ADDENDUM No. 1

ITB No. 4680

City of Ann Arbor WWTP Clear Well Improvements

NORTH CLEAR WELL

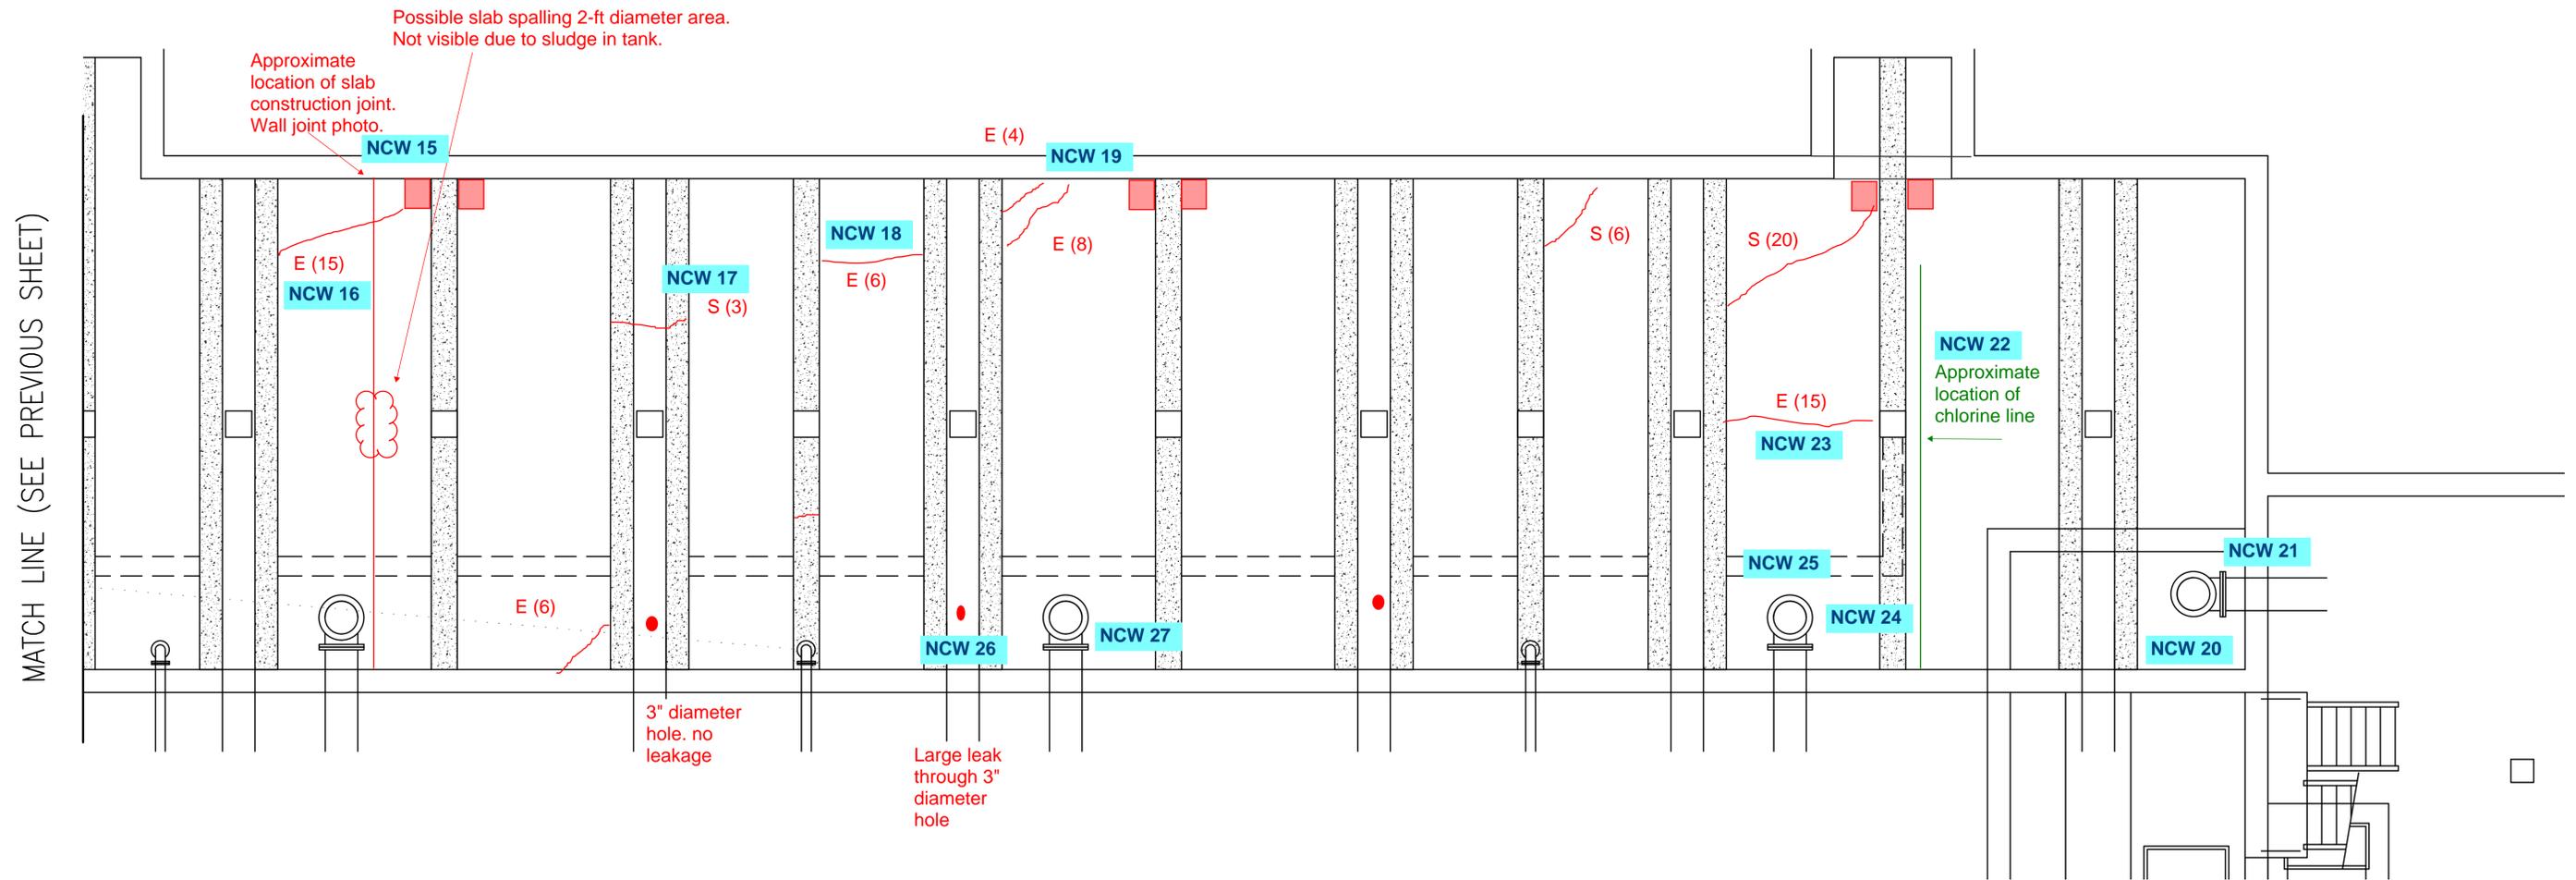
- There are no expansion joints in this clear well.
- The ceiling is in good condition and not stained as it is above the operating water level.
- There were circular areas on the underside of the wide beams/ troughs at the bottom of the filter cells that require concrete restoration. Several small holes that appeared to be tie- holes from the original construction, or possibly the location that the vertical resteel was anchored for the Westech supports for the 1997 underdrains. Several of these areas were actively leaking which would have been water remaining in the underdrain troughs from the shutdown. These areas will need to be dried and patched.
- There was intermittent cracking along the ceiling of the structure and efflorescence was visible. The efflorescence is produced when the free lime in the concrete reacts with water. The water causing the

- The walls and columns require no structural action at this time.
- The wall control joints, and some miscellaneous cracks had sealant that was either absent or had been deteriorated. It is recommended that these joints and cracks be sealed.

- The CMU baffle wall was deteriorating primarily at the location of the Filter Effluent discharge bells near the ceiling of the clear well. Recommend complete removal of the baffle wall. The interfaces to the base slab and ceiling to be patched. The requirement of a new baffle wall and design to be explored as part of the alternatives analysis.

SOUTH CLEAR WELL

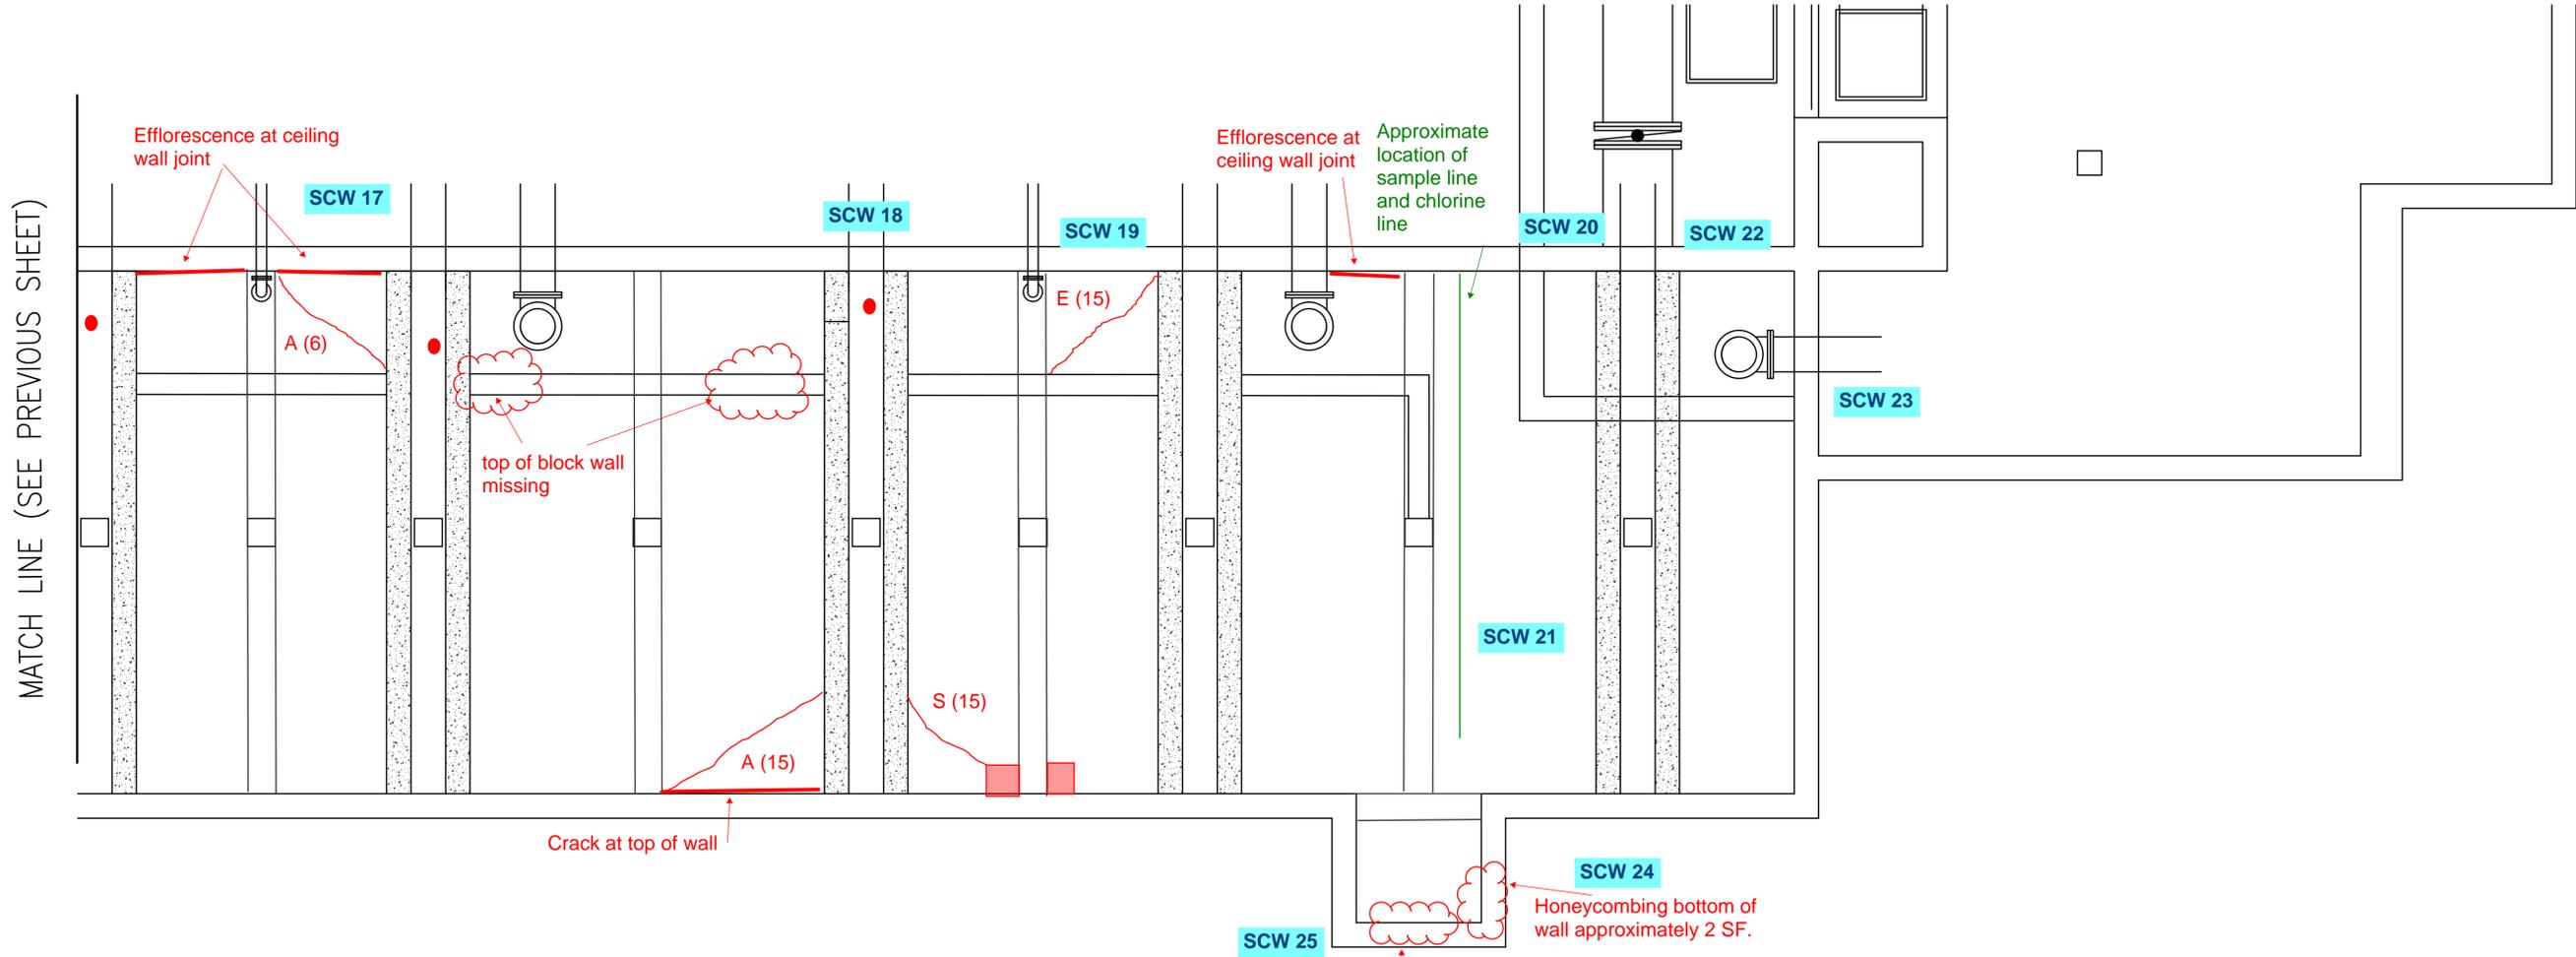
- We noted concrete spalling at the top of one column as noted on the plan in Attachment 3 and photo SCW 9A and 9B that requires patching.
- The walls and columns require no structural action at this time.

- Isolation gates were leaking which will also need to be addressed for construction.
- Several ladder rungs for the clear well were missing as noted in the plan in Attachment 3. Recommend replacement of the missing rungs.
